Subject: River St and Western Ave Bridges Reconstruction

Robert Antico re: Anderson Bridge Reconstruction Project
March 14, 2010

Appendix

Conceptual Diagram: River Street Bridge and surrounding roadways

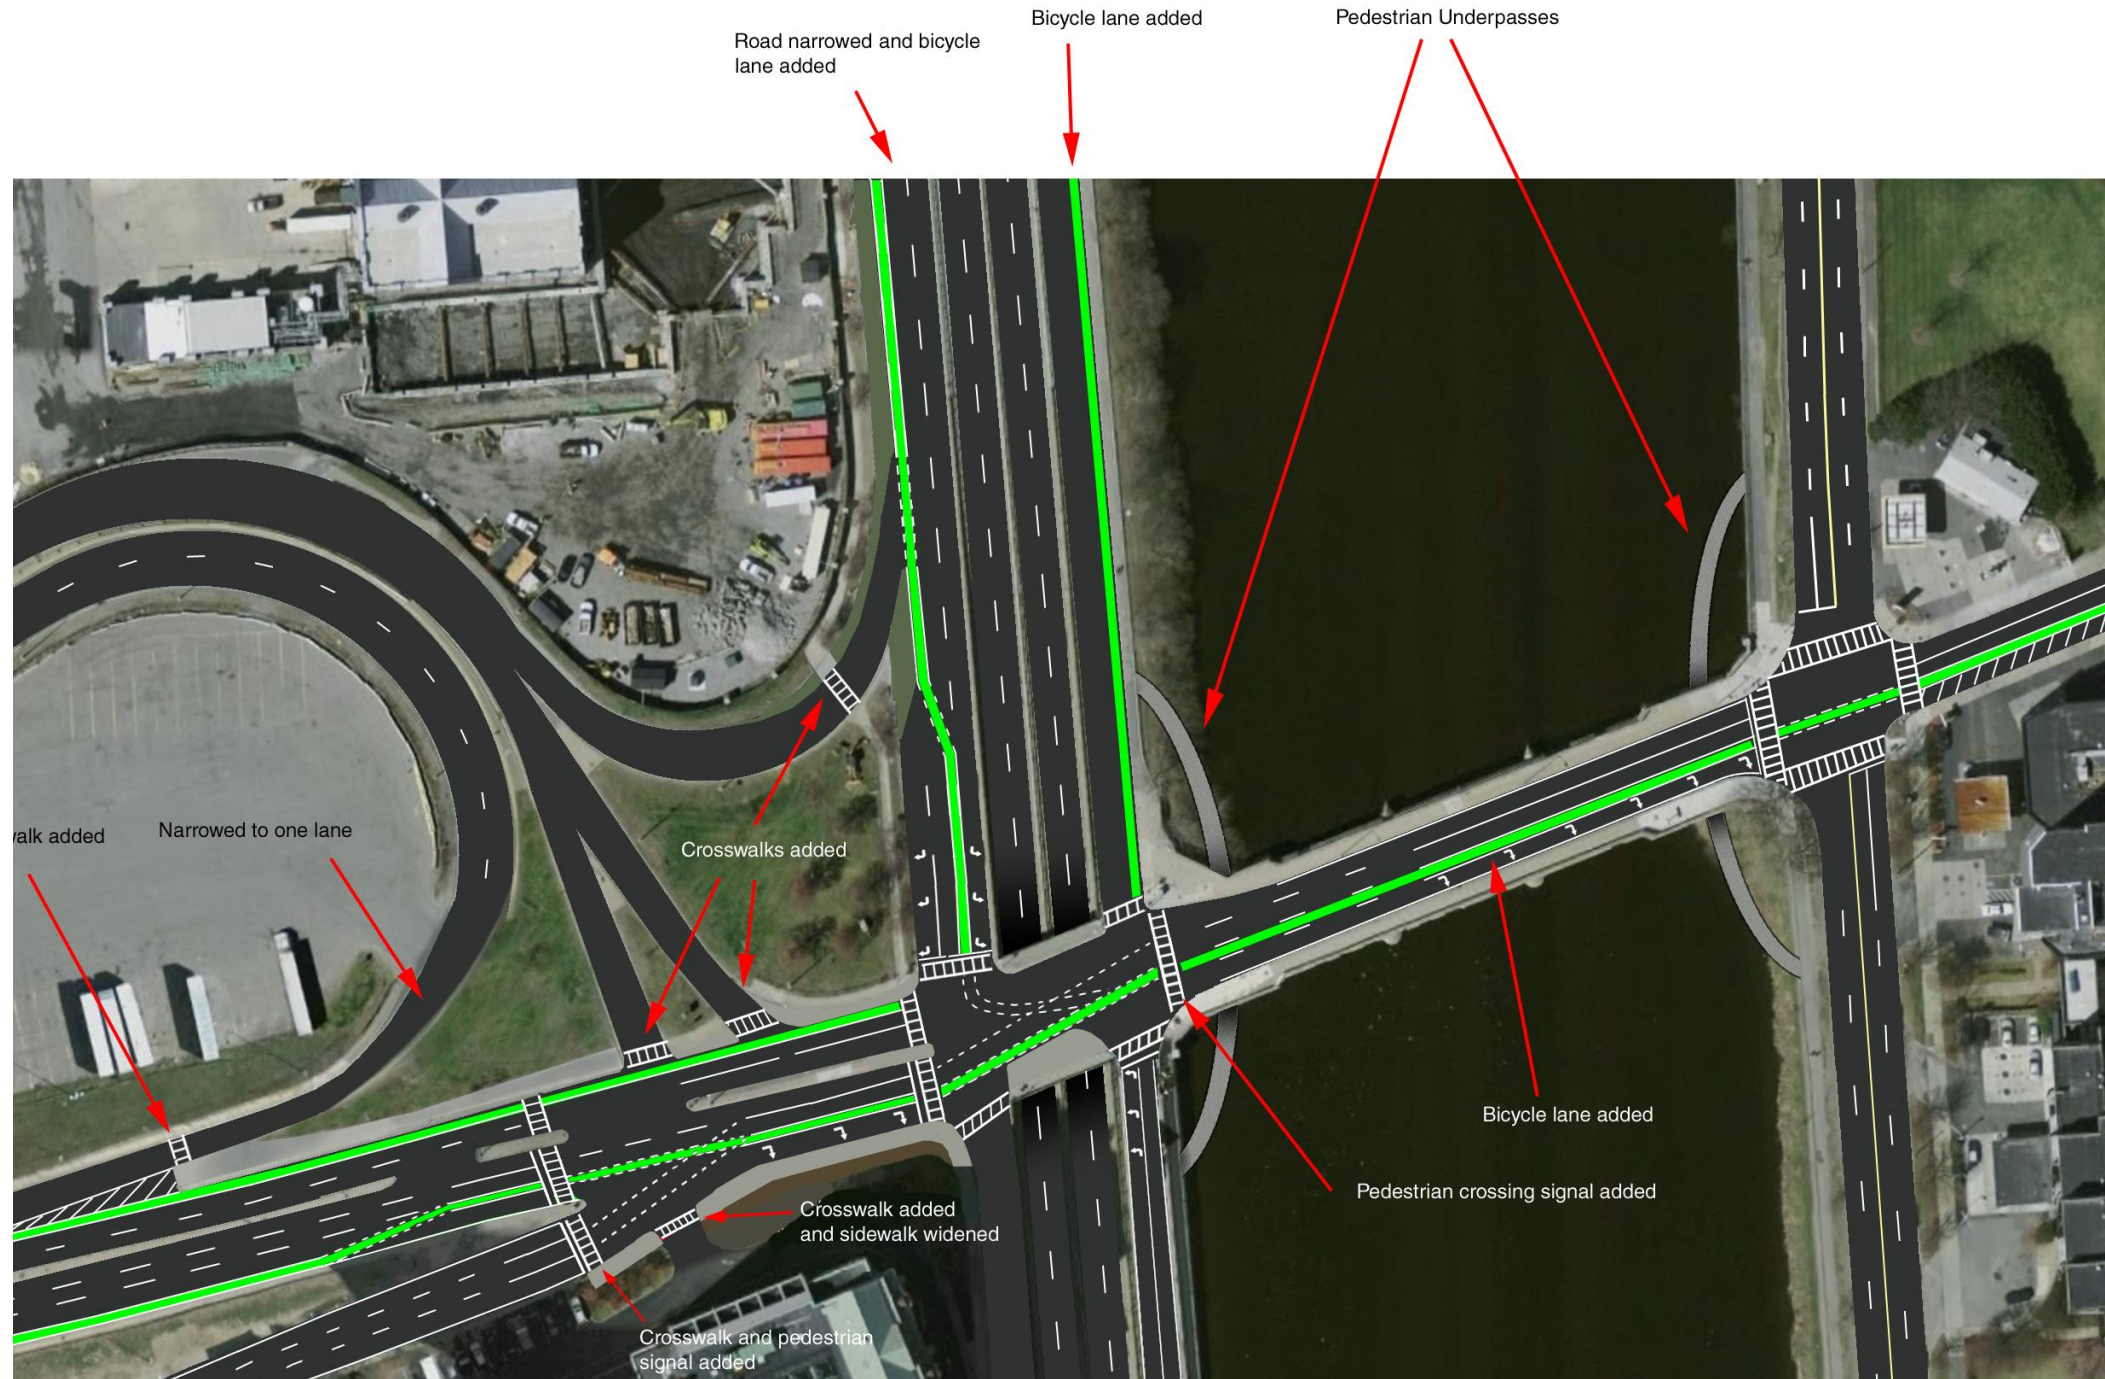
Planned cycling lanes

Cycling lane conduit added

Conceptual Diagram: Western Ave Bridge and surrounding roadways

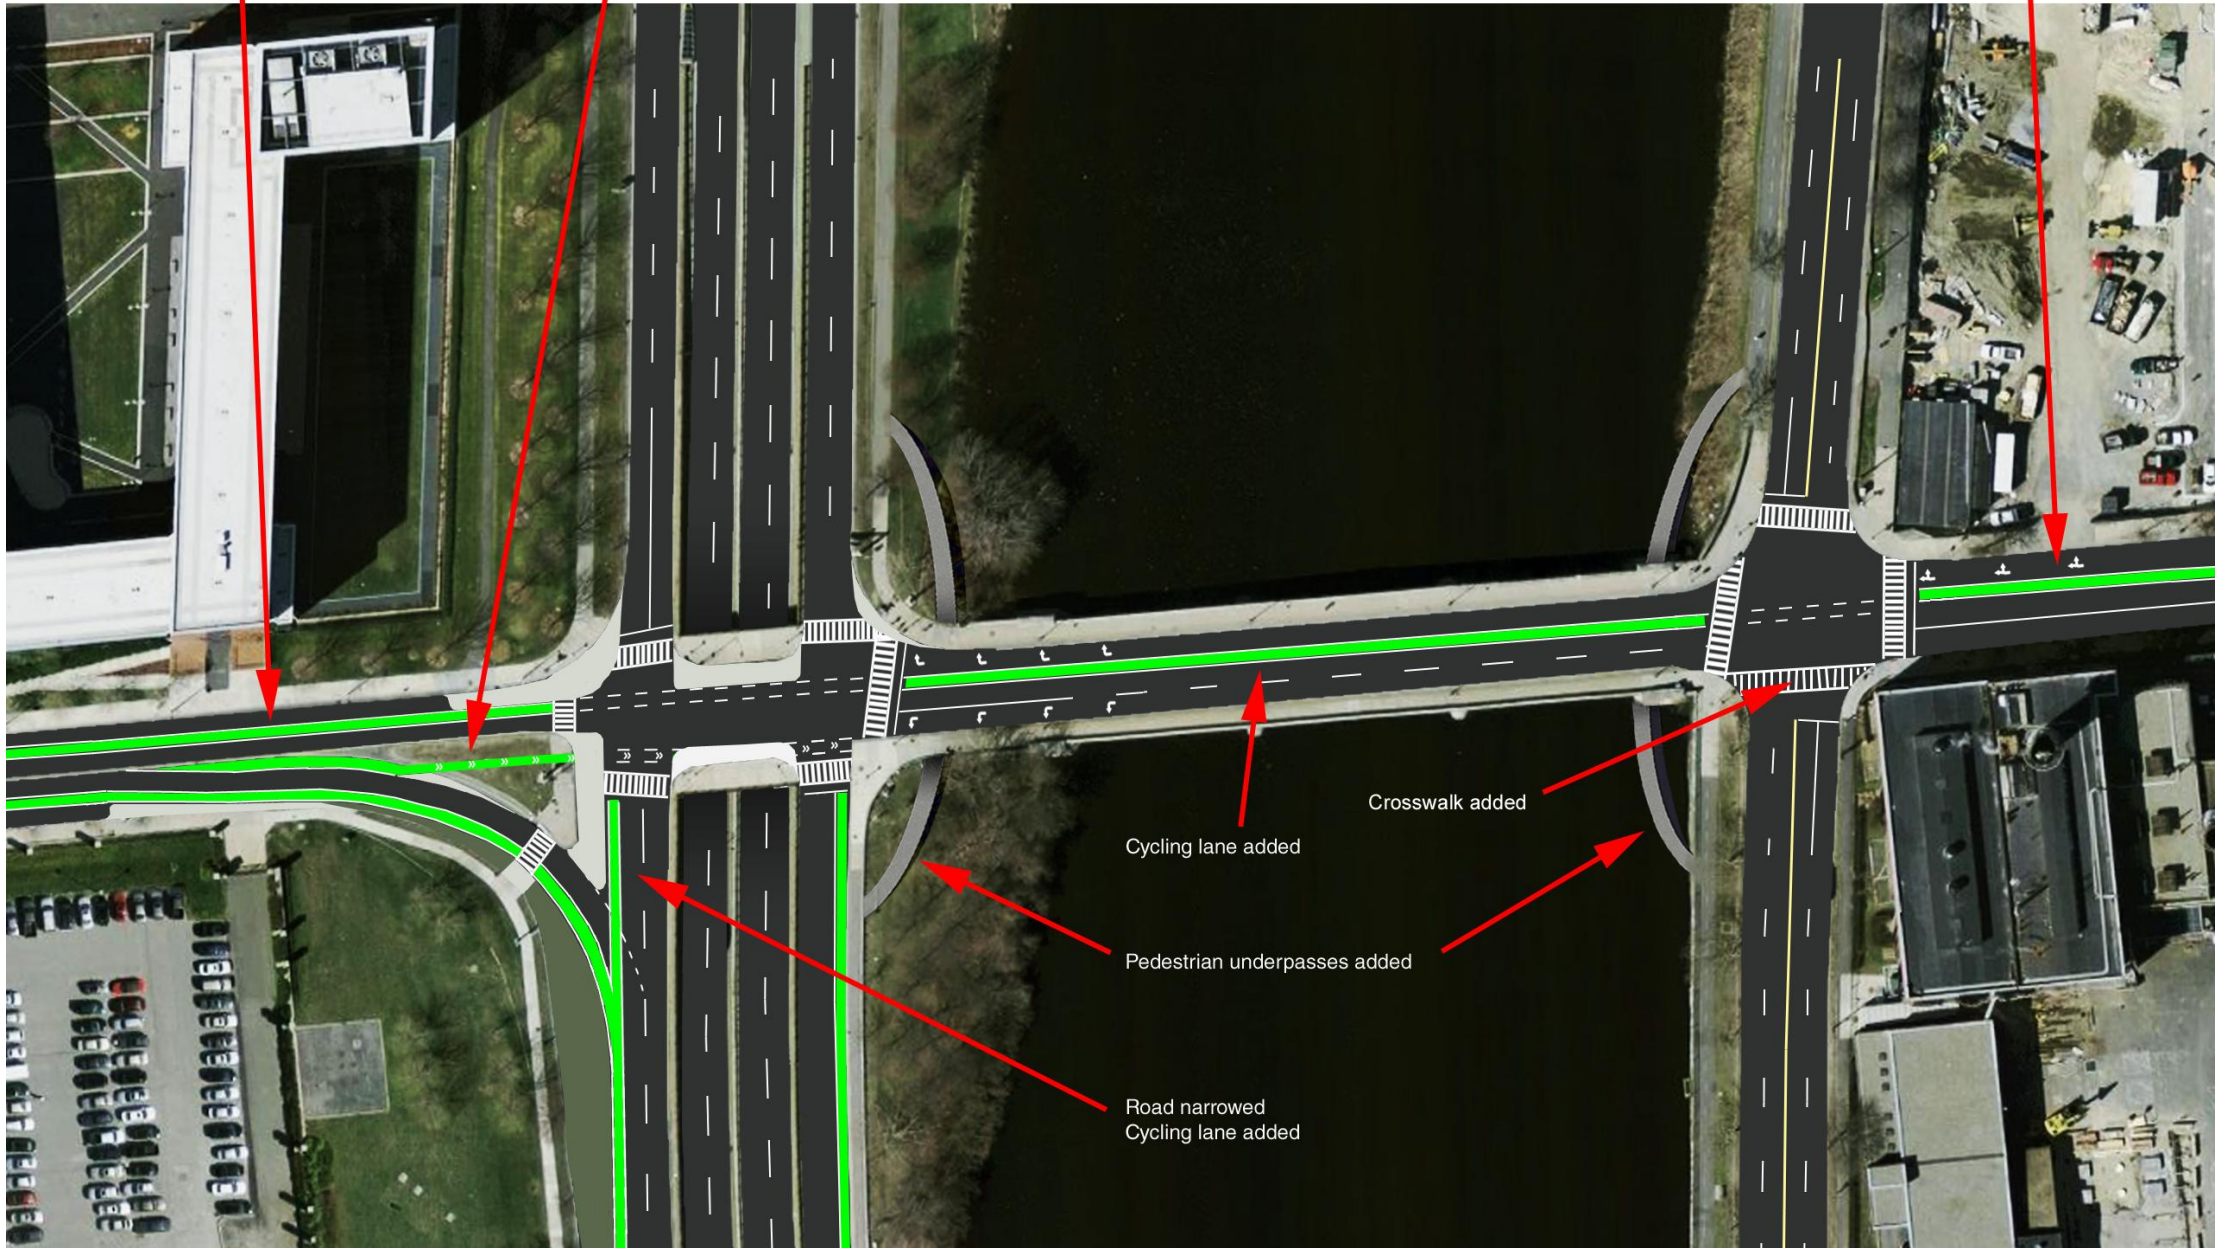
Planned cycling lane

Cycling lane added

Crosswalk added

Pedestrian underpasses added

Road narrowed
Cycling lane added
